Review of “Gas flaring activity and black carbon emissions in 2017 derived from Sentinel-3A SLSTR” The paper attempts to locate all the active gas flares of 2017 and estimate their flare gas volumes using nighttime data collected by the Sea and Land Surface Temperature Radiometer (SLSTR) instrument flown on-board the Copernicus satellite Sentinel-3A. The basic detection algorithm for the individual nights of data follows the VIIRS nightfire (VNF) method and appears to be solid. But the steps used to go from the individual nights of data to the annual summary are questionable and should be revisited.

Fig. 1. Temporal profile VNF SWIR radiance for a flare in Siberia. Each year there is an outage period due to solar contamination.

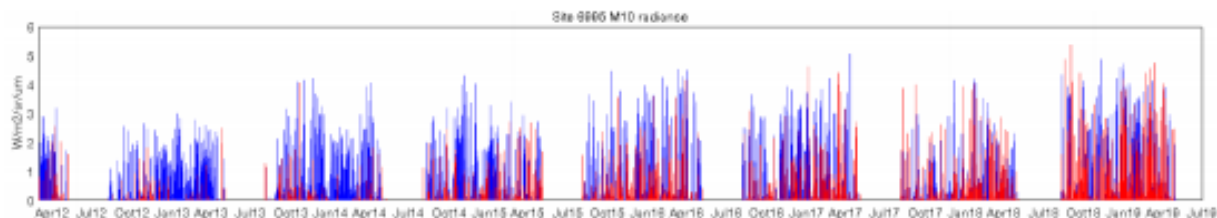
2. Many flares are intermittent. The nightly flare detection data does not contain sufficient information to account cloud and solar contamination effects that could effect the annual flared gas volume calculation. Hence the annual characterization of flared gas volume should calculate the “duty cycle” or “percent frequency of detection” for each flaring site. The VNF team makes the calculation based on flare detection numbers in the set of nighttime cloud-free observations made of the site during the year. Because the nightly VNF product only contains the detections – the annual analysis includes an

inventory of the cloud state (cloudy or clear) for the nights lacking VNF collection that are free of solar contamination. The VNF method excludes both sunlit and cloudy observations in the calculation of flaring site duty cycle. The method reported in this paper (section 2.3 and Figure 2) is woefully inadequate and appears to have resulted in a drastic underestimation of annual flared gas volume in Russia. I suspect that the method in Figure 2 does not account for solar contamination outages during summer months – as shown below with VNF for a flare in northern Siberia.

We acknowledge that the method for correcting for variable observation opportunity is less sophisticated than the one employed in VNF. It should, however, be capable of partly correcting the effect partial and complete solar contamination. The underlying assumption is that SLSTR happened to observe a few gas flaring locations in mostly cloud-free condition during 2017. With almost continuous operation, these should be the locations with the largest numbers of detections. In this case, the numbers of detections are also estimates for the numbers of detection opportunities, including the effects of number of satellite overpasses and solar contamination. The number of satellite overpass times increases for higher latitudes; this should increase this largest number of detections for higher latitudes. On the other hand, the summer period during which more observations are contaminated with solar radiation is longer for higher latitudes. This has the opposite effect of reducing the largest number of detections for higher latitude. The latter effect appears to be stronger, given the behaviour depicted in Fig. 2. An additional error occurs due to the variability in average percentage of cloud cover, which the presented method approximates to be constant zonally and to vary smoothly meridionally. Therefore, the method is considered to be applicable with less effort but also less accuracy than a detailed recording of the detection opportunities for each flaring site. In particular, this method should improve the results when only information on hot spot detections but not on detection opportunity is available.
